Prepared for
School Infrastructure NSW

Date
9 September 2022

Submissions Report

Murwillumbah Education Campus

Figure 2 Location of Nest Boxes

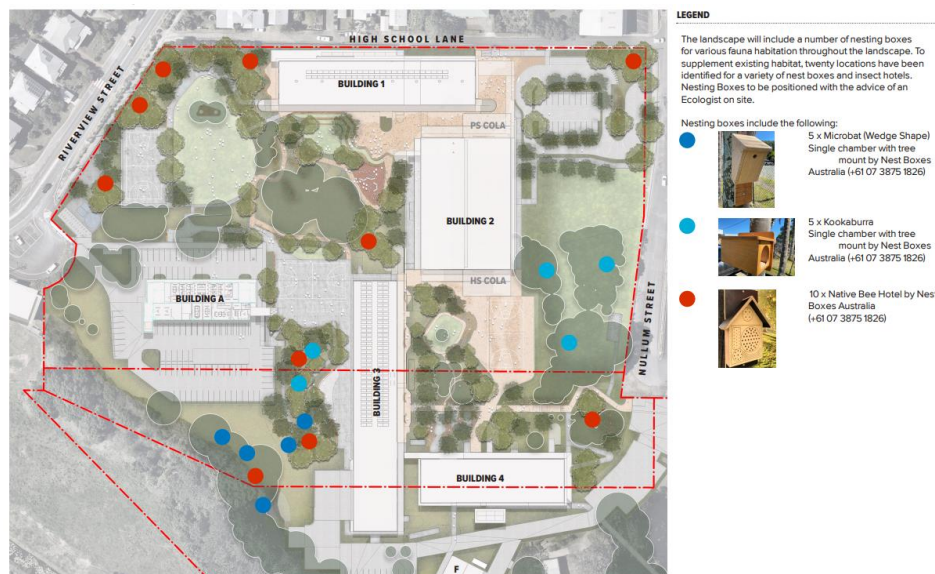
- **Fauna** – Tweed Shire Council supported the assessment of potential impacts in relation to fauna, including threatened species, however also stipulated that there may be opportunities to provide supplementary habitat for threatened microbat species in the proposed landscaping through the provision of nest boxes.
- **Development Footprint** – The BCD has raised issues with the Biodiversity Development Assessment Report (BDAR). It considered that the development footprint does not encompass all construction and operational phase components of the project, including areas of proposed demolition and the location and extent of proposed bushfire asset protection measures that require clearing or modification of native vegetation.

- **Fauna** - A revised Landscape Design Report has been prepared by Arcadia which can be found at **Appendix P** and provides the location for nest boxes. Their location is reproduced in **Figure 2**. The type of nest boxes and their locations have been verified by the project ecologist, EMM Consulting, as being suitable.

Figure 3 Proposed assembly point and evacuation route
 Source: FERP as prepared by TTW

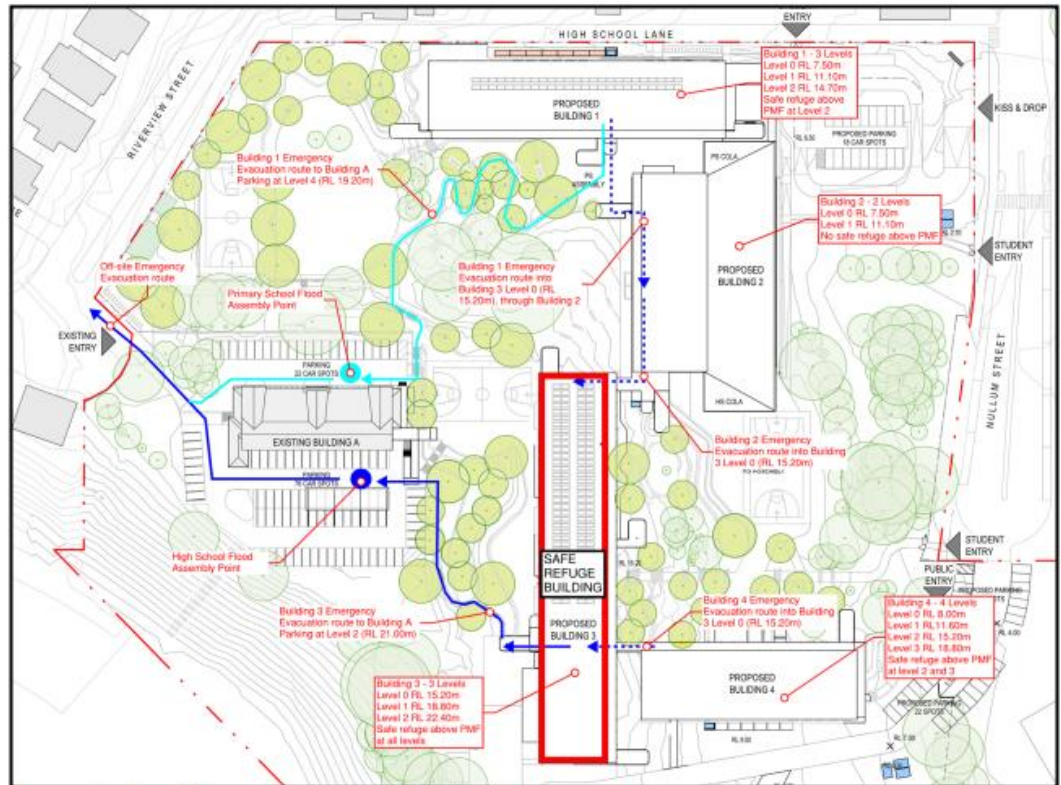
- **Flood Emergency Management Plan** – DPE requested a flood emergency management plan be prepared in consultation with the NSW State Emergency Service (SES).

As a contingency, and where a flood incident has not been foreseen, TTW recommends a shelter in place response. Evacuation from the site is proposed as a strategy when there is sufficient warning time before the onset of flooding and it is safe to do so. The school PA system would be used to communicate with staff and students during flood events. TTW recommends flood evacuation drills be completed once a year so that all students are aware of the site evacuation routes and emergency assembly point. Refer to **Figure 3** below.
